1044b UIC - EAST POPLAR OIL FIELD  
ENFORCEMENT CASE SDWA 1431  
Folder ID: 13637 2001 Privileged

BIERE 1 22 WELL REMEDIATION & MONITORING PLANS  
RECEIVED AFTER NOVEMBER 30 2000

Re: Biere Well Site, East Poplar Oil Field: Comments on Draft  
Administrative Order on Consent

**REVIEW AND COMMENTS ON "Monitoring Plan for Shallow Groundwater-  
Biere Well Response Action Project, January 30, 2001"**

## Option #2

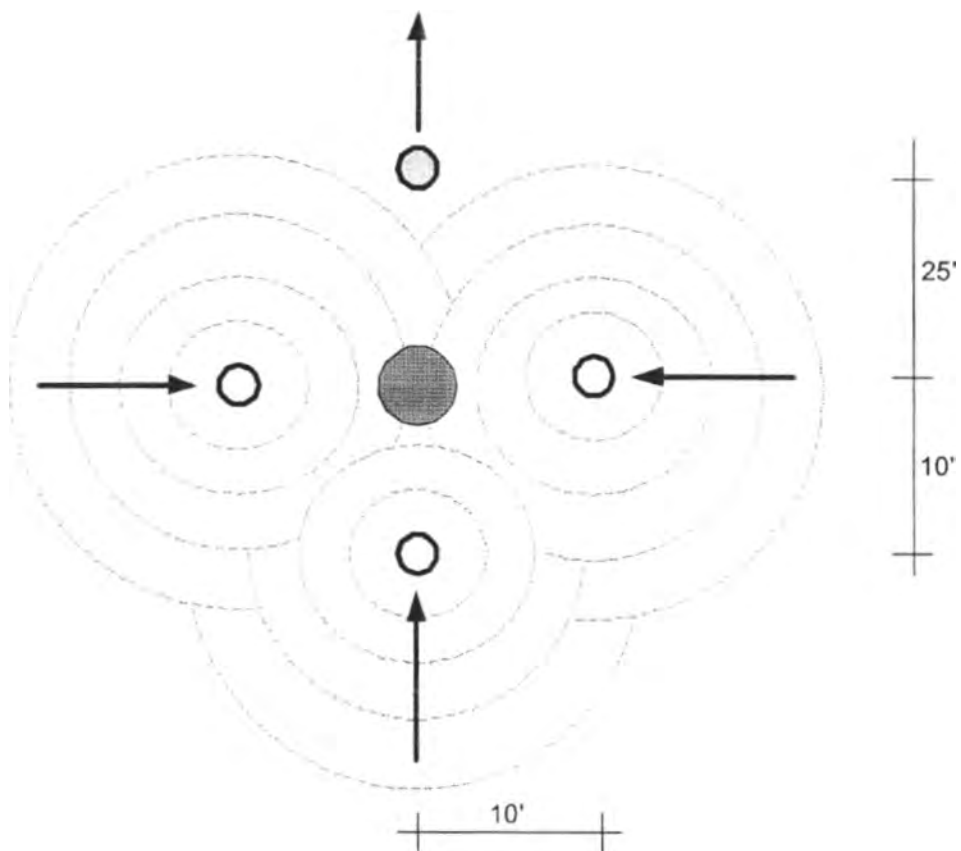
2. The figures that accompanied the Plan showed Pioneer's preferred well spacing (so-called Option 2). This spacing should be modified to spot the three injection wells around the Biere 1-22 well in an equilateral triangular pattern, where each injection well would be located 120° of arc from the each other. This pattern would provide a greater level of assurance that the injected chemical shut-off fluid would adequately surround the Biere 1-22 wellbore and form a tighter barrier within the top 32 feet of the Judith River sandstone.

2. The figures that accompanied the Plan showed Pioneer's preferred well spacing (so-called Option 2). This spacing should be modified to spot the three injection wells around the Biere 1-22 well in an equilateral triangular pattern, where each injection well would be located 120° of arc from the each other. This pattern would provide a greater level of assurance that the injected chemical shut-off fluid would adequately surround the Biere 1-22 wellbore and form a tighter barrier within the top 32 feet of the Judith River sandstone.

Response: Spacing the wells equilaterally about the Biere 1-22 well bore would indeed be advisable if we were only using three wells to effect a complete 360° seal. However, we also intend, if necessary, to use the relief well as a chemical squeeze injection well after it is initially used to monitor the movement of the Injectrol-U chemical pumped into the other three wells. The relief well will be re-entered and cleaned out to the Judith River prior to chemical injection into the other wells, and then will serve as an excellent monitor well at depth to assess the efficacy of the seal.

We expect that the chemical injection program from the three injection wells will expand enough to reach the relief well. But if necessary, injection will occur into the relief well to seal off that well and provide additional encapsulation for the Biere 1-22 well bore.

**Figure 1**  
**Wells Located in the**  
**Vicinity of the Biere Wells**

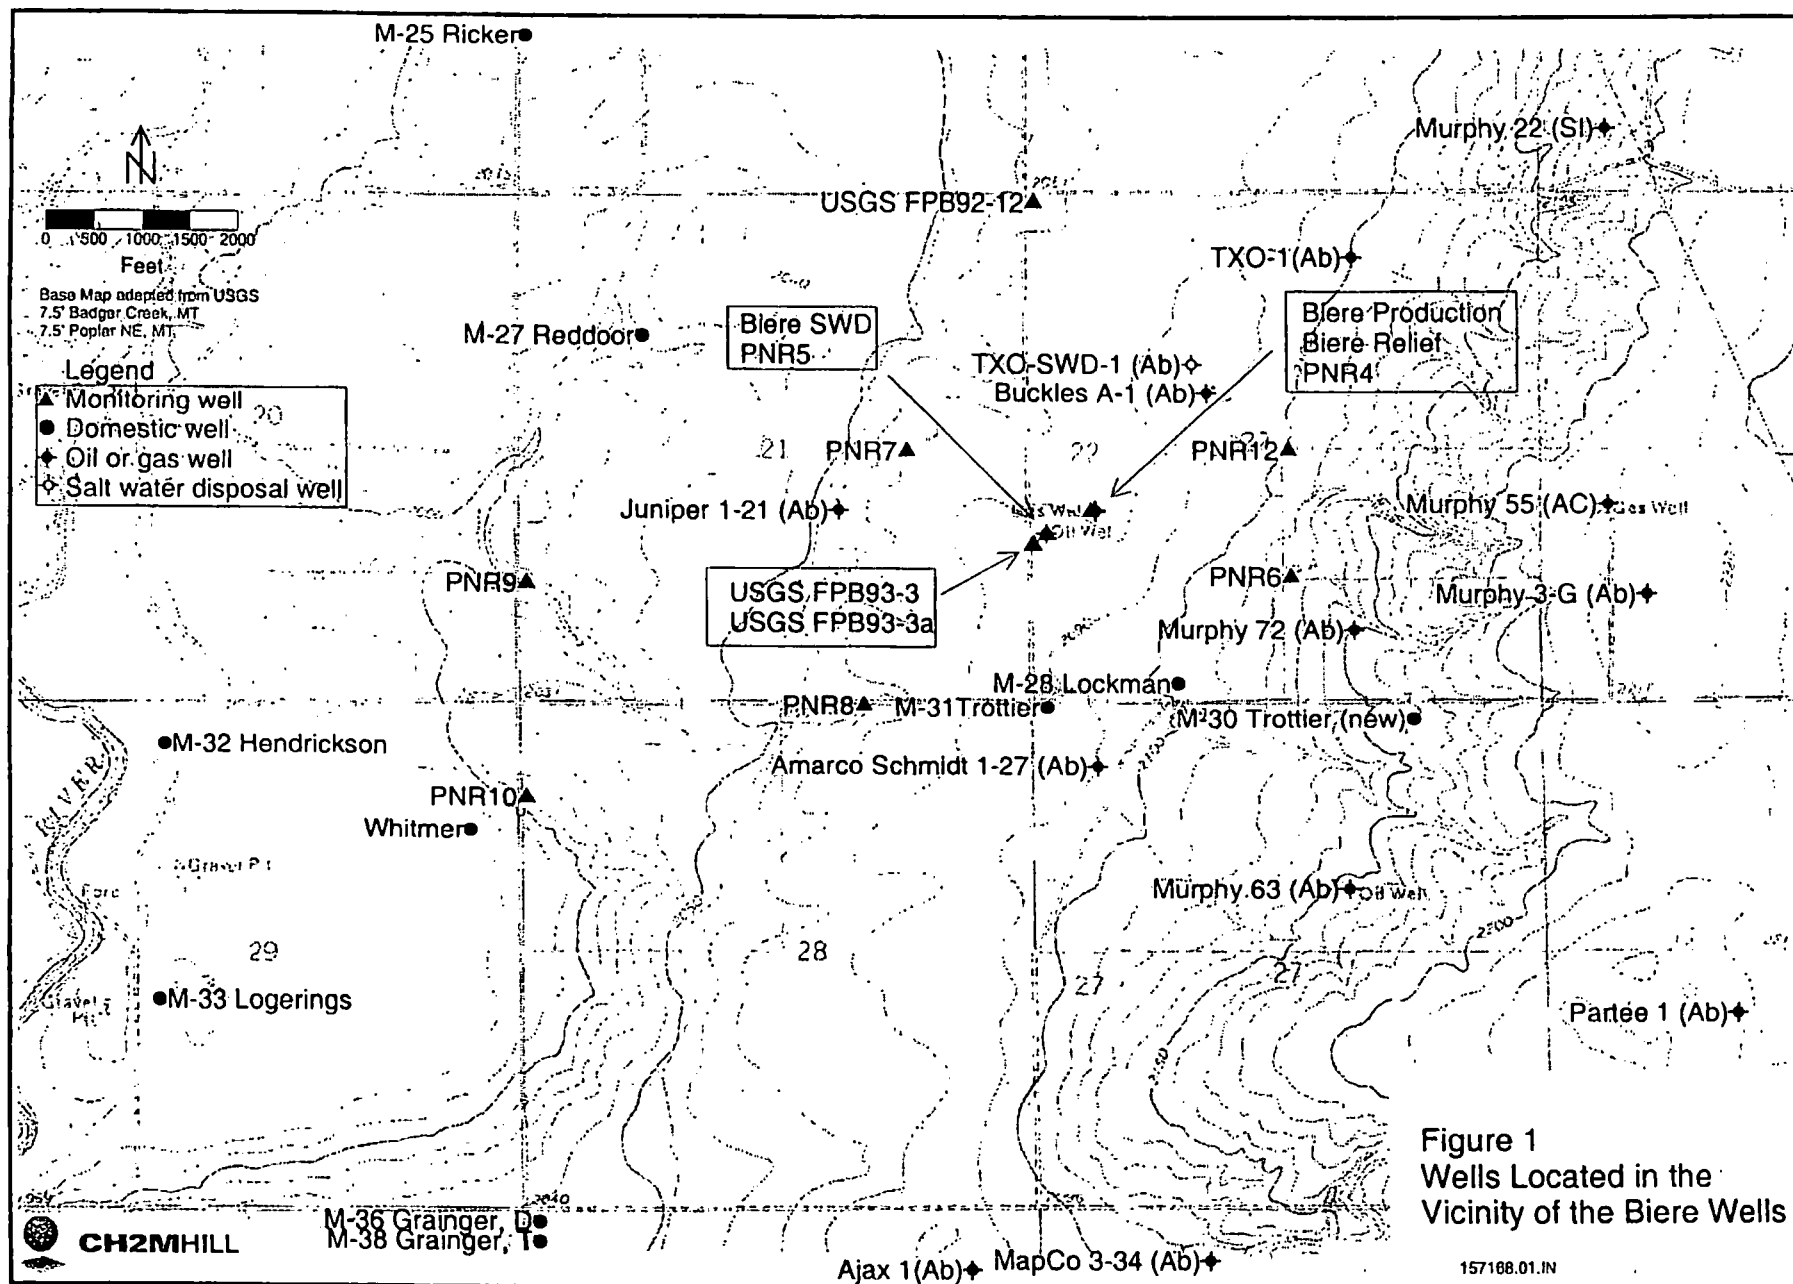
- 1) The well location demonstrating maximal contaminant concentrations (temperature and organic hydrocarbons) is PNR4. However, this well contains a sizeable layer of free oil product which constrains routine sampling. Special techniques have been proposed in the monitoring plan to deal with the problem. However, it is somewhat uncertain whether reliable data can routinely be obtained for the study;

Finally, it is recommended that existing well PNR8 be included in the quarterly monitoring scheme rather than the semi-annual group. The remainder of the more distant monitoring wells proposed in the plan can continue on a semi-annual monitoring basis. Although potentiometric measurements are proposed for each sampling event in the plan, the measurement should be noted as an additional parameter for this study, since potentiometric changes might occur faster than chemical ones.

■ = ERM-suggested additional monitoring well sites (10 sites)

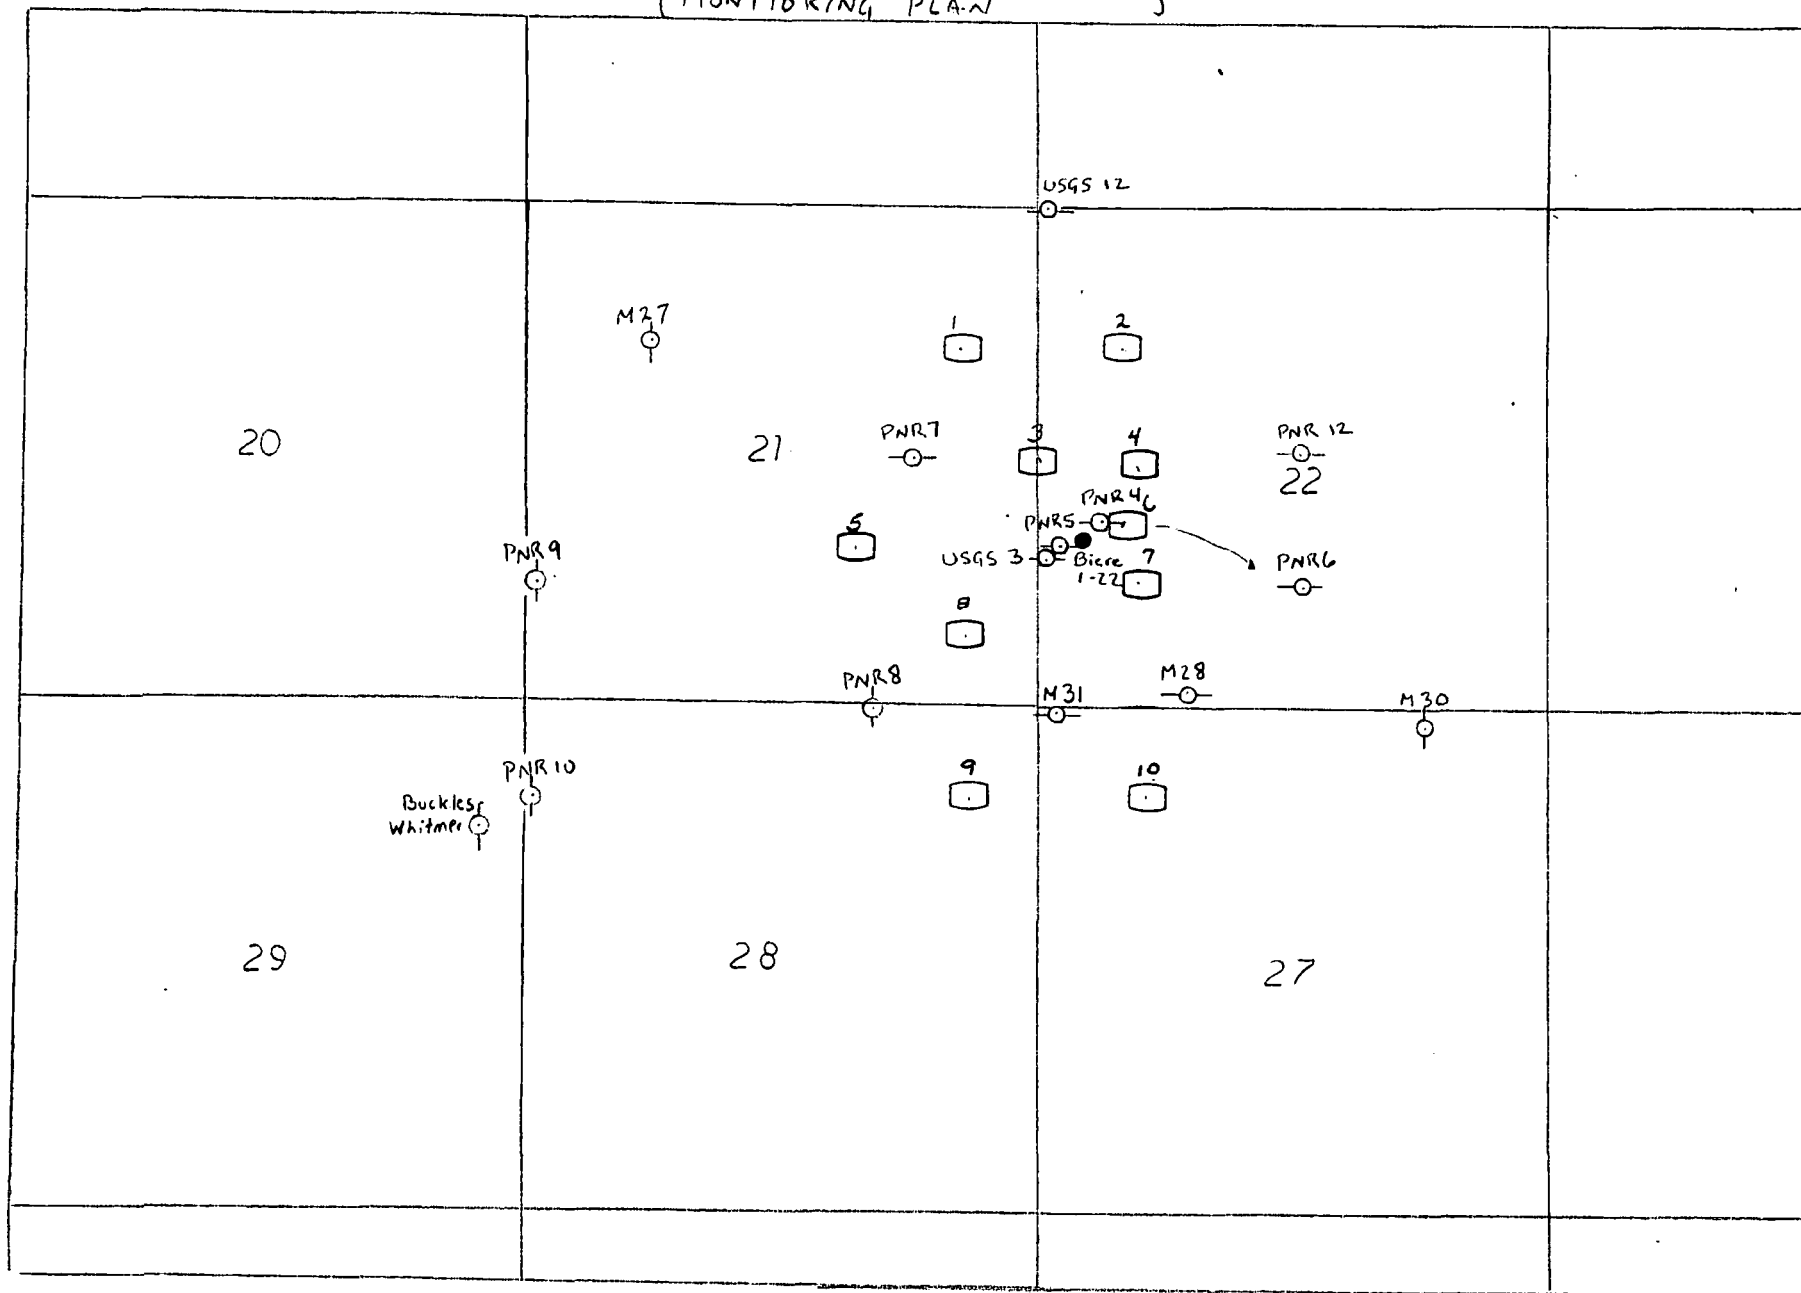
Based on the above considerations, the attached map Figure 1 is provided suggesting additional well sampling locations. In total, ten new well locations are suggested. Assuming a source somewhere in the vicinity of the existing Biere location shown as a black dot, a roughly orthogonal array of wells was developed. To the greatest extent, existing wells were included in

the framework. Thus, proposed wells #3, #4 and #6 along with either well PNR5 or USGS93-3 lie in four perpendicular directions approximately 500' from the probable source. Water chemistry and temperature data suggest that wells PNR5 and USGS93-3 provide nearly identical information and one may be redundant. A additional proposed well #10 is shown with a question mark. It might be useful to consider locating a new well between the Biere disposal and production wells in the hopes of avoiding the extensive oil contamination yet still serving as the maximum source well in the monitoring system.

Proposed wells #7, #8, and #9 are suggested to fill in critical information gaps towards the south and also provide additional information (at wells #7 and #5) regarding presently observed anomalies at existing well PNR8. Proposed wells #1, #2, and 5# are also located to provide improved spatial information for areas to the west and north.

□ = EPA-suggested additional monitoring well sites (10 sites)

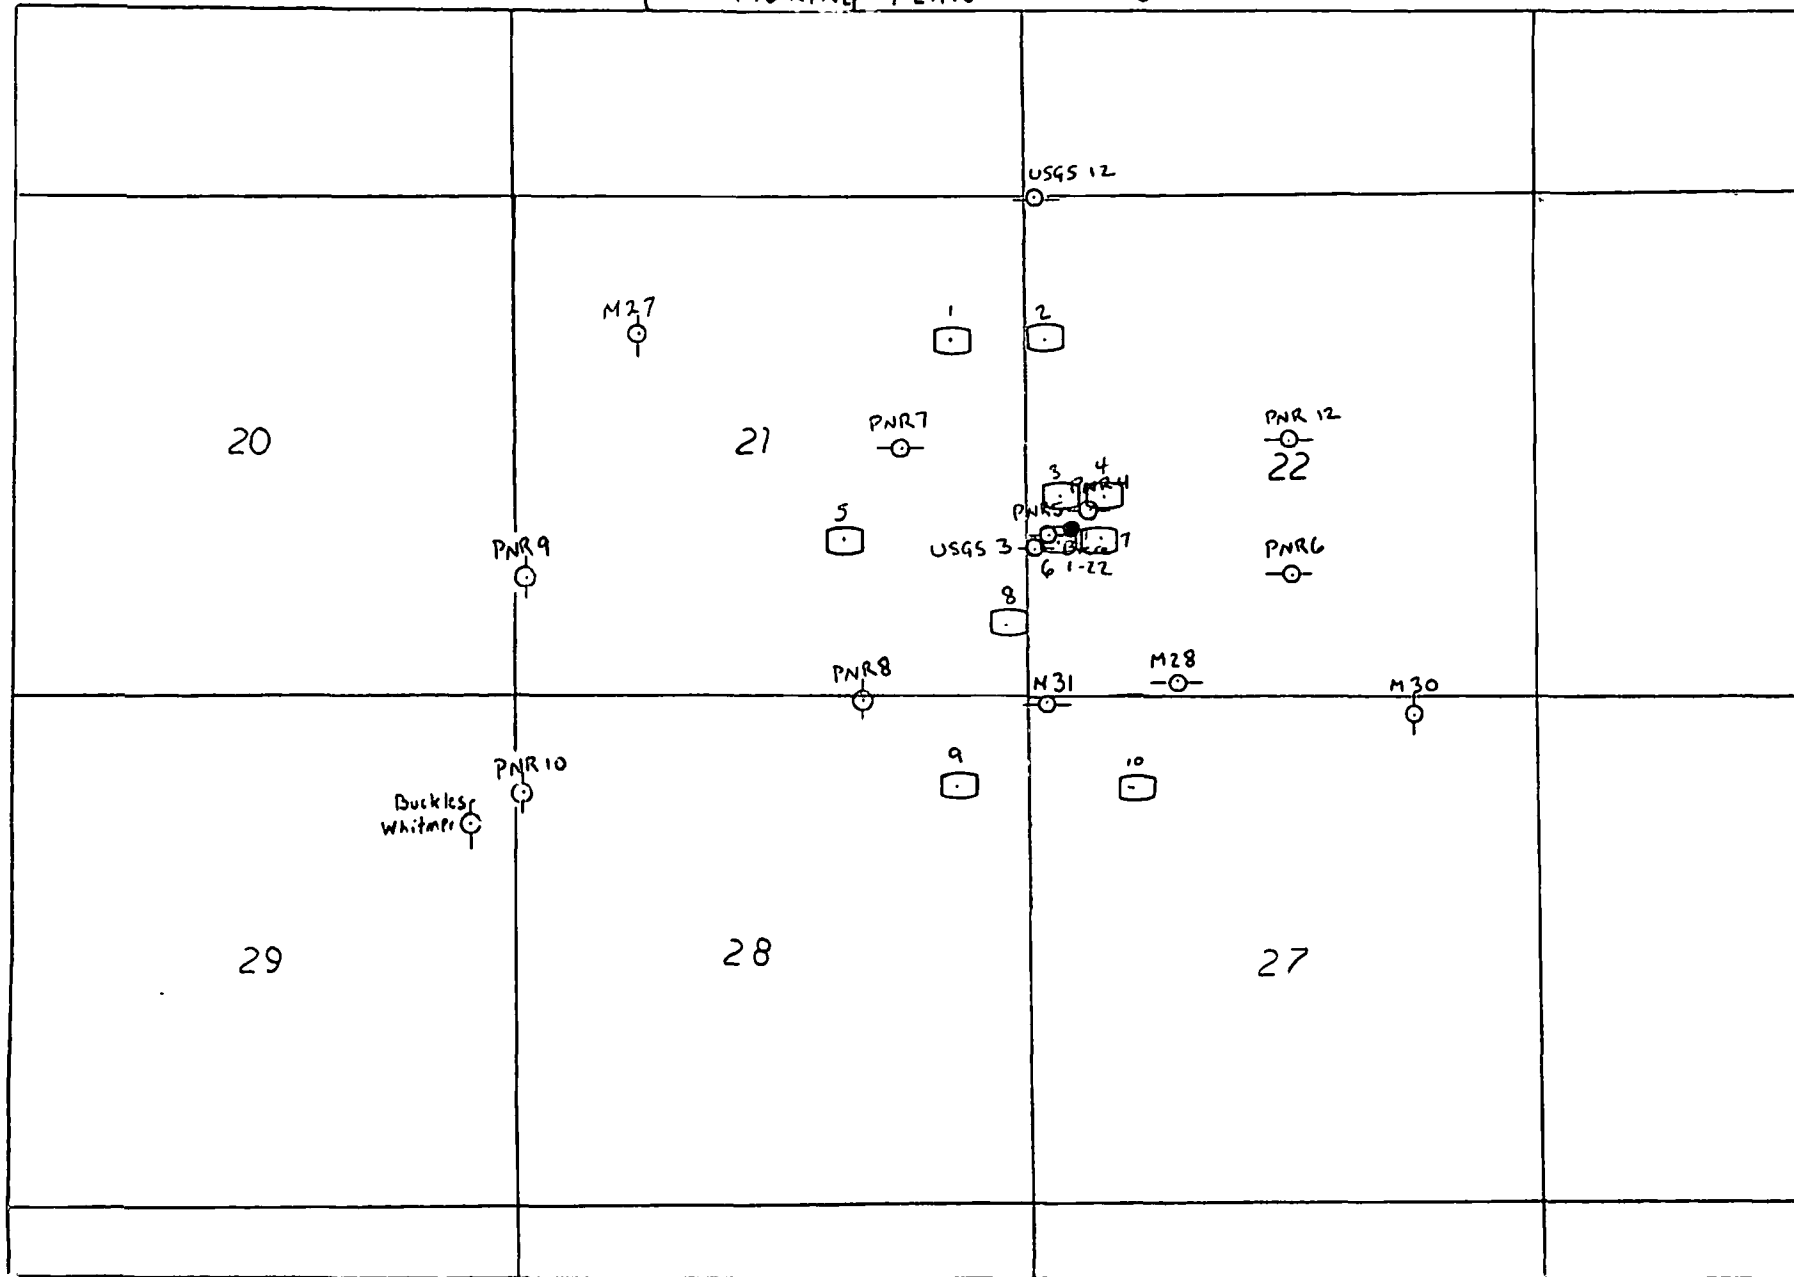
Re: Comments on January 30, 2001 Proposed  
Monitoring Plan for the Shallow Groundwater  
Pioneer Natural Resources USA, Inc.  
Biere 1-22 Production Well  
East Poplar Oil Field  
Roosevelt County, Montana

The United States Environmental Protection Agency ("EPA") appreciates the opportunity to comment on the Monitoring Plan for the Shallow Groundwater, dated January 30, 2001, (the "Plan") proposed by Pioneer Natural Resources USA, Inc. ("Pioneer") in the vicinity of the Biere 1-22 well. Nathan Wiser, of my staff, has consulted with other groundwater monitoring well design experts in the office, as well as the United States Geological Survey ("USGS") in the preparation of this letter. We appreciate your continued willingness to seek EPA's comments on these matters.

Pioneer will install 10 additional monitoring wells in the vicinity of the Biere well at the approximate locations shown on Figure 1. Final well locations are subject to site-specific access and landowner restrictions but Pioneer will strive to locate the wells as close to the proposed locations as possible.
